RE: 17TH STREET CANAL PARALLEL FLOOD PROTECTION
PHASE 1B - HAMMOND HIGHWAY TO SOUTHERN RAILWAY
OLB PROJECT NO. 2043-0207

In your letter of October 21, 1988, you listed comments on our preliminary plans for the above referenced project. In our review of those comments, we discovered that the slope stability calculations for the first six reaches of this project do not properly reflect the actual factors of safety.

We are submitting revised slope stability and sheet pile analyses for Reaches 1 through 6 which supersede the previously submitted calculations and consequently make obsolete comments "a" and "b" of your letter of October 21, 1988.

REACH 3
STA. 589+00 TO STA. 614+00

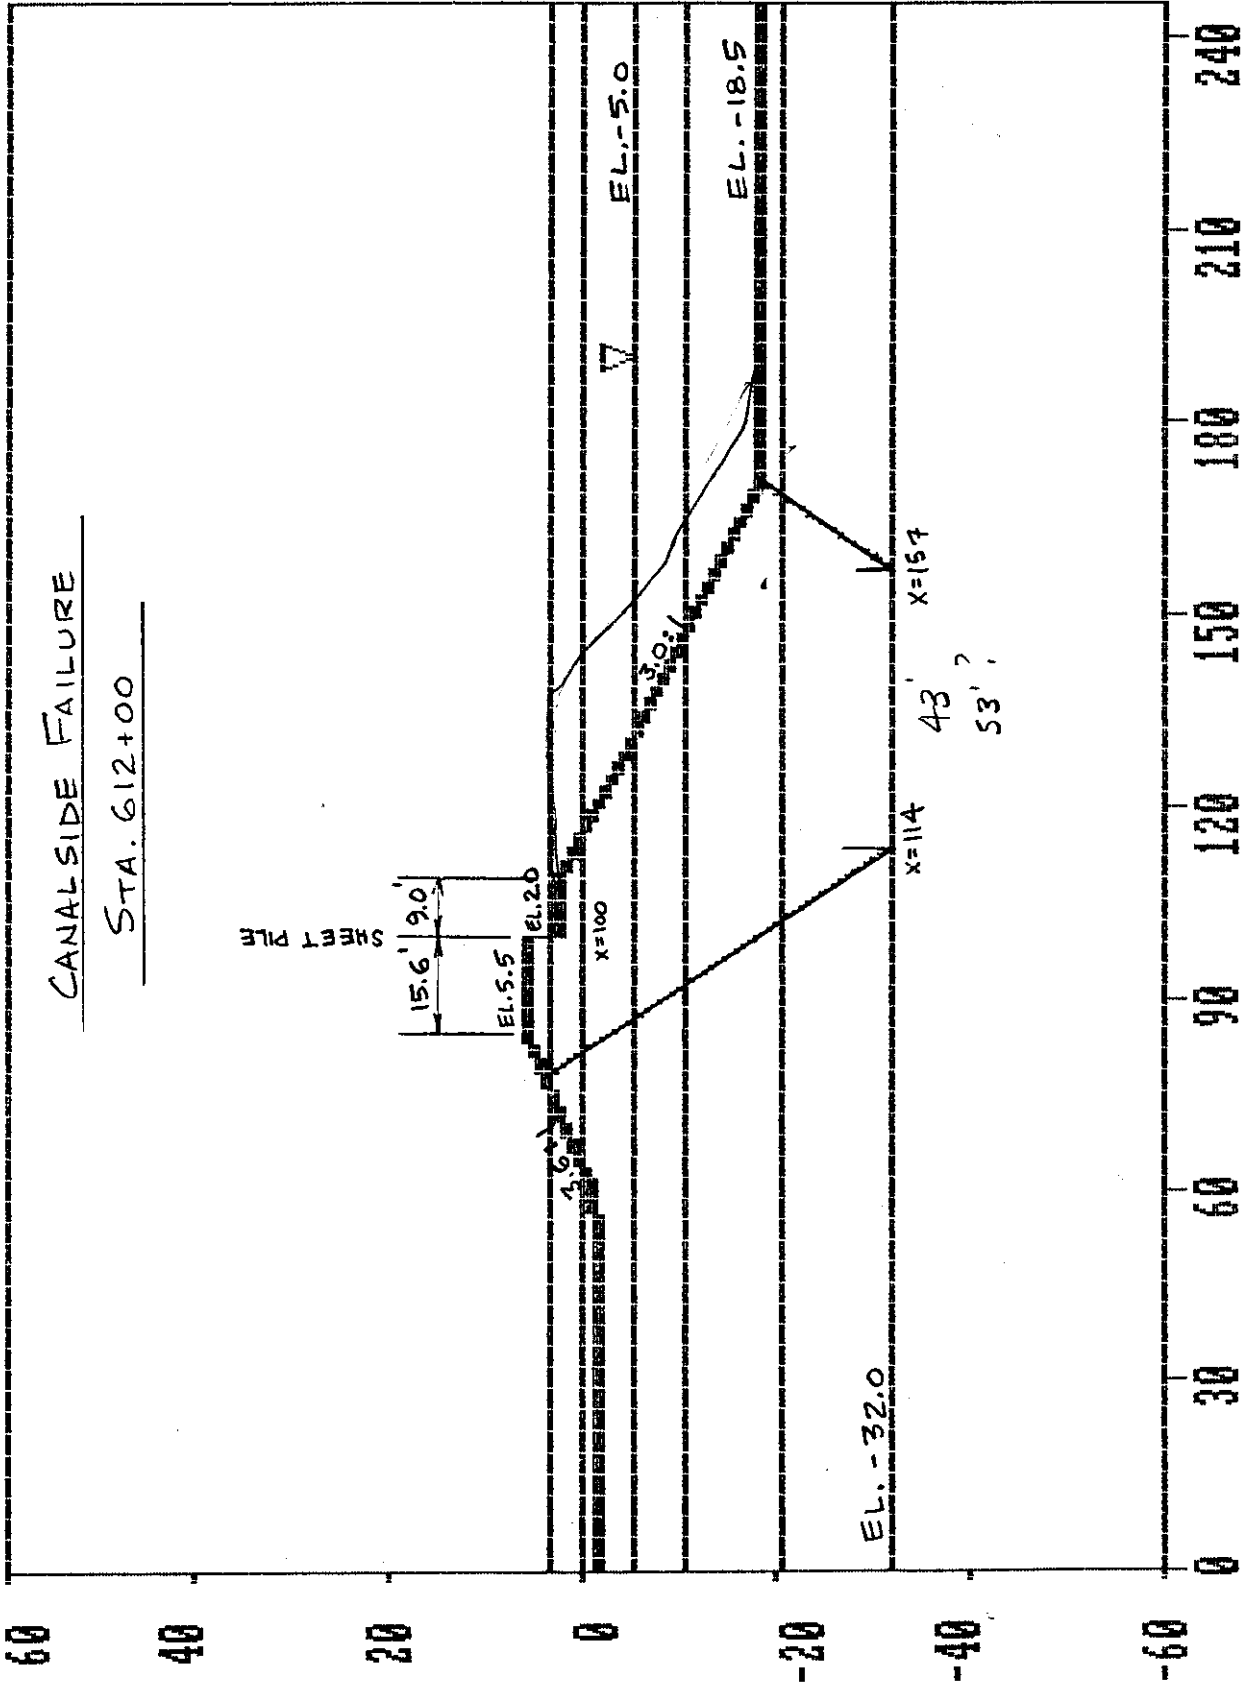
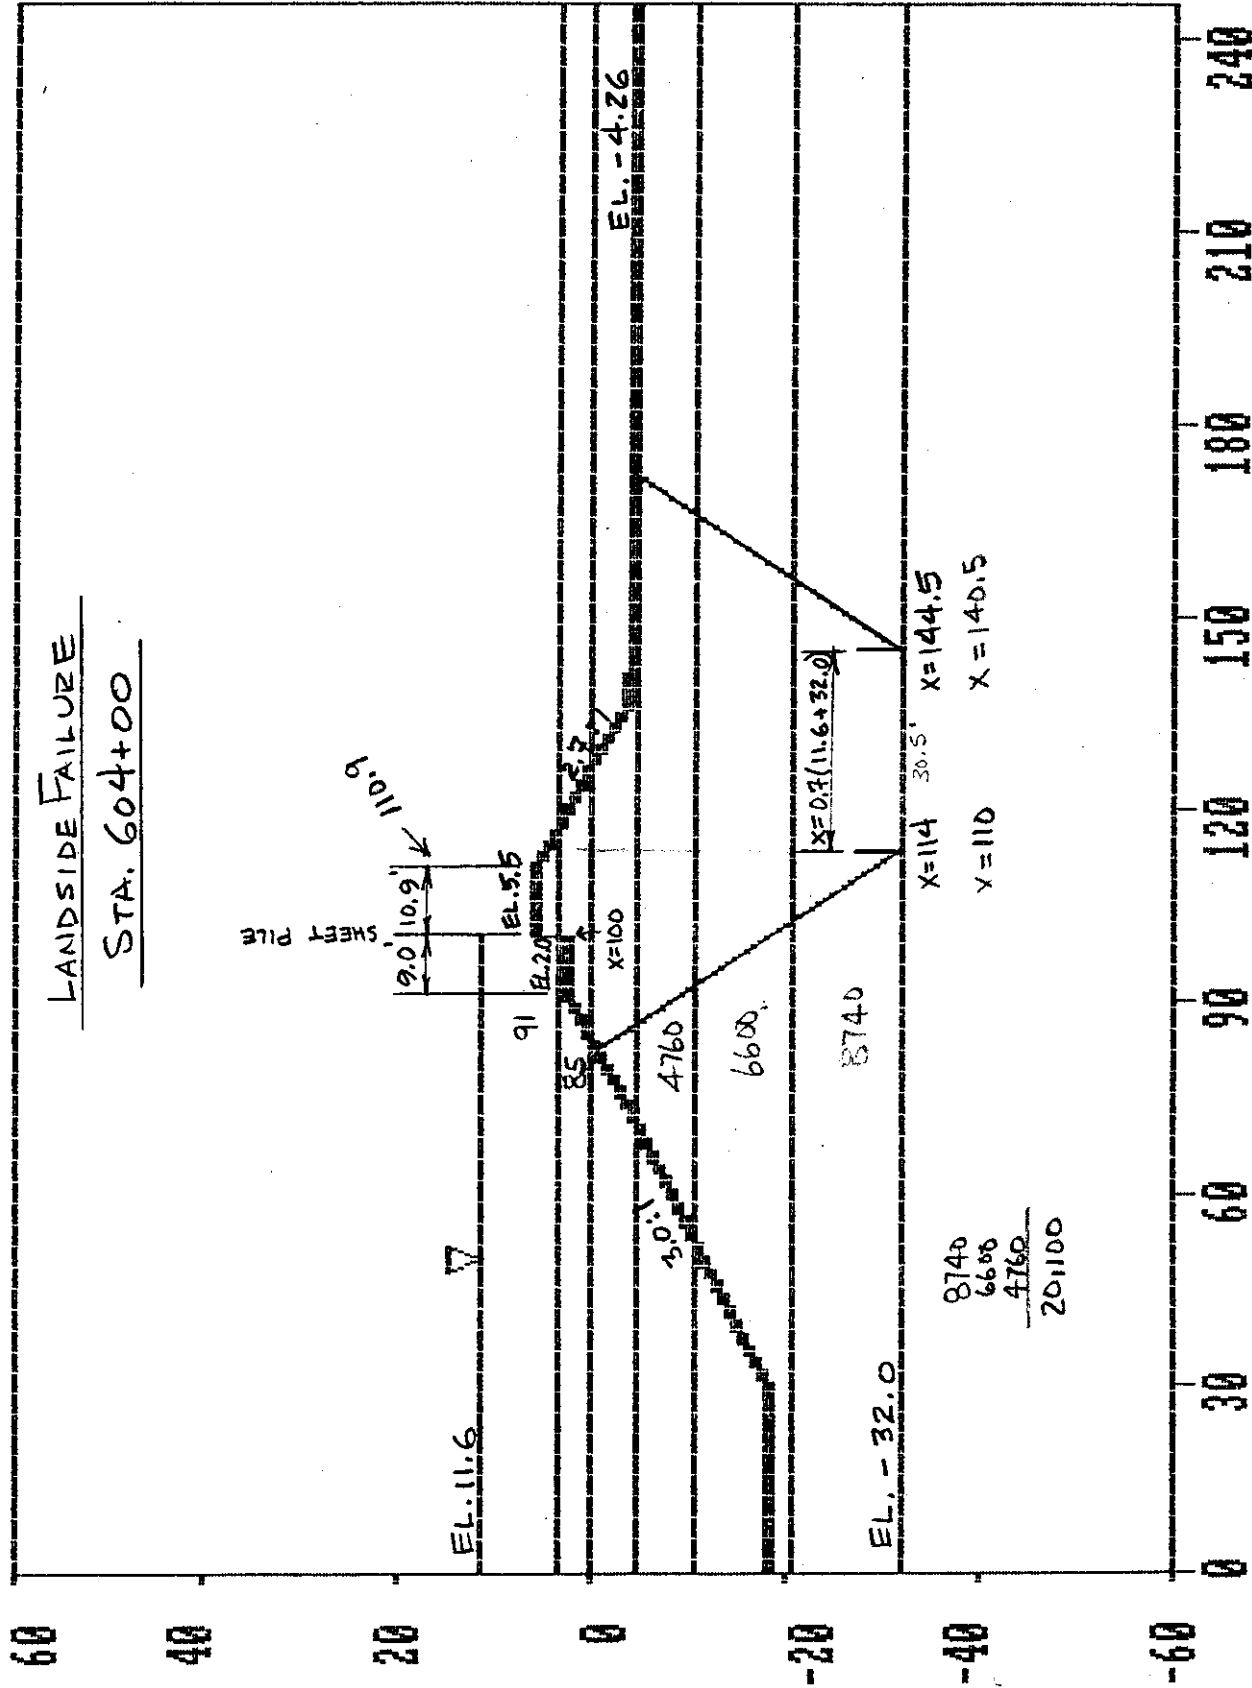
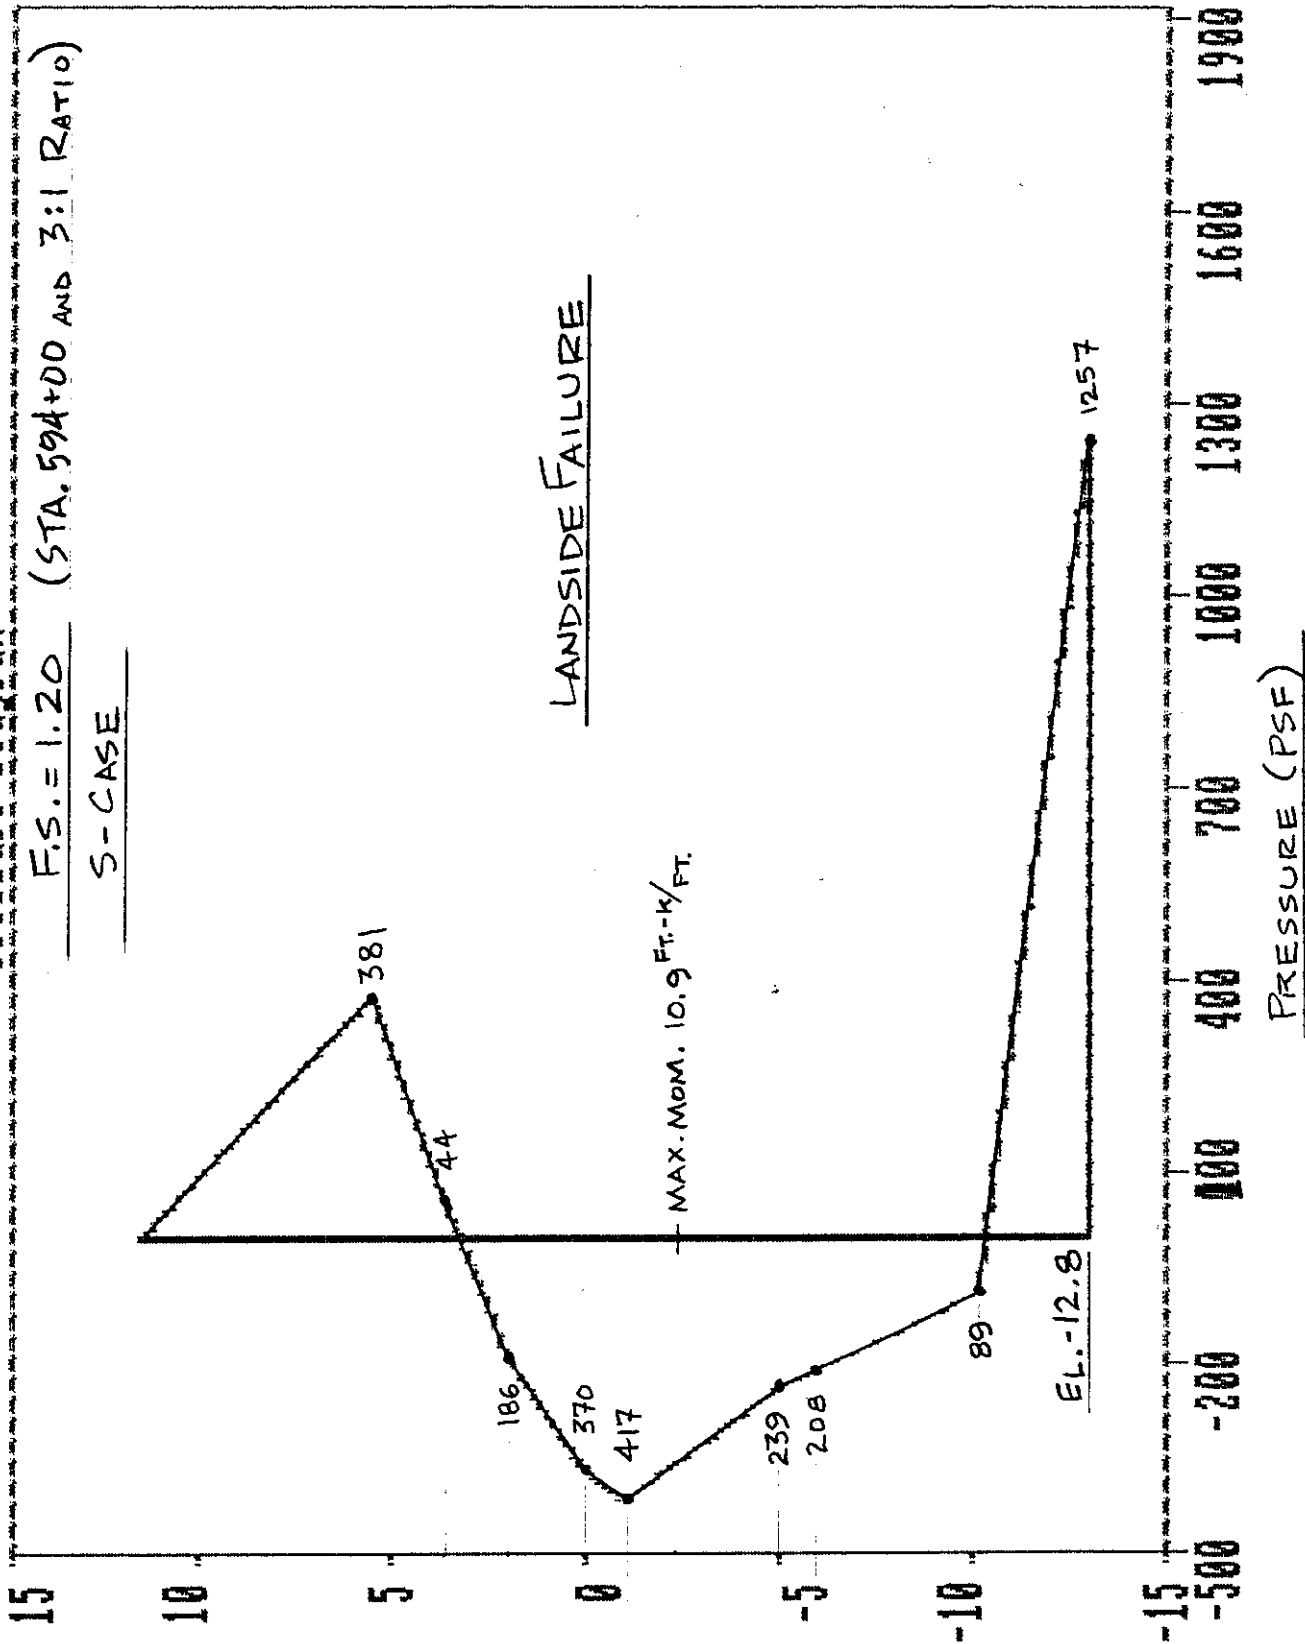
Revisions to Cross-Section : Realign Sheet Pile
 Lower Crown Elevation to El. 5.5 **6.5**
 Lower Step Elevation to El. 2.0 and Decrease Width to 9.0' **19.8'**

$$\begin{aligned}
 &20,352 \quad 11,590 \quad 18,812 \quad 1.27 \\
 &20,821 + 11,598 + 18,855 = 1.30 \quad (M+M \text{ If use}) \\
 &54,853 - 15,425 = 39,428 \rightarrow \text{same wedge} = 39,602 \\
 &79,437 - 39,373 = 40,064 \quad \text{Active } \phi_{DA-DP}
 \end{aligned}$$

Canalside Failure - 612+00. ***** Minimum Factor of Safety = 1.32 *****

Landside Failure - 590+00, 592+00, 594+00, 596+00, 600+00, 604+00 and 606+00.
 The section at Sta. 604+00 governs. ***** Minimum Factor of Safety = 1.30 *****

Required Penetration : -12.8 (Landside Failure Sta. 594+00 and 3:1 Ratio; S-Case F.S.=1.2)
 Design Bending Moment : 10.9 Ft-K/Ft @ El. -2.3 (Landside Failure Sta. 594+00 and 3:1 Ratio; S-Case F.S.=1.2)
 Maximum Deflection : In.
